BAR Action March 18, 2014:

BAR 14-03-05

500 Court Square

Change baluster material

TYPICAL BALUSTER

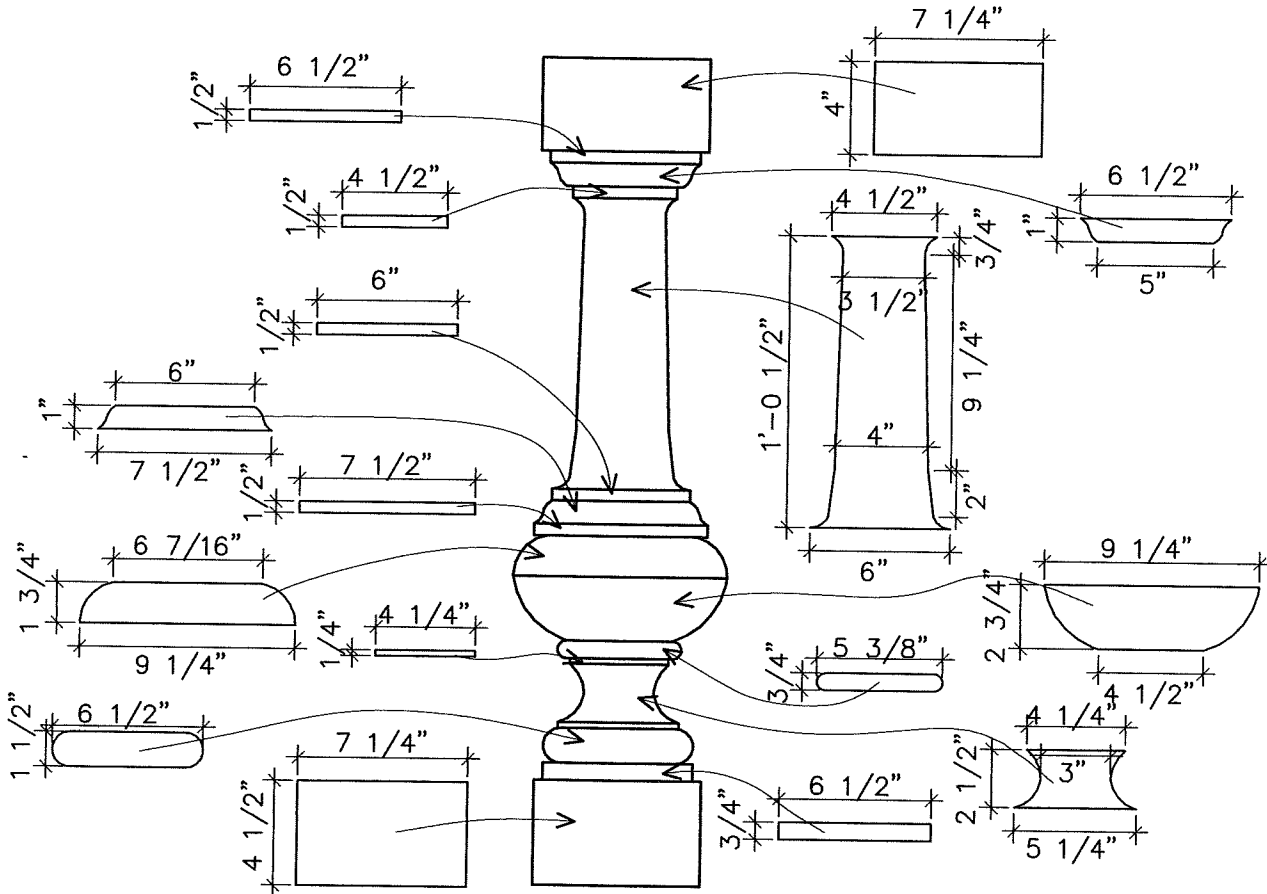
The BAR approved (5-0) the change in baluster material from painted copper to fiberglass as submitted.
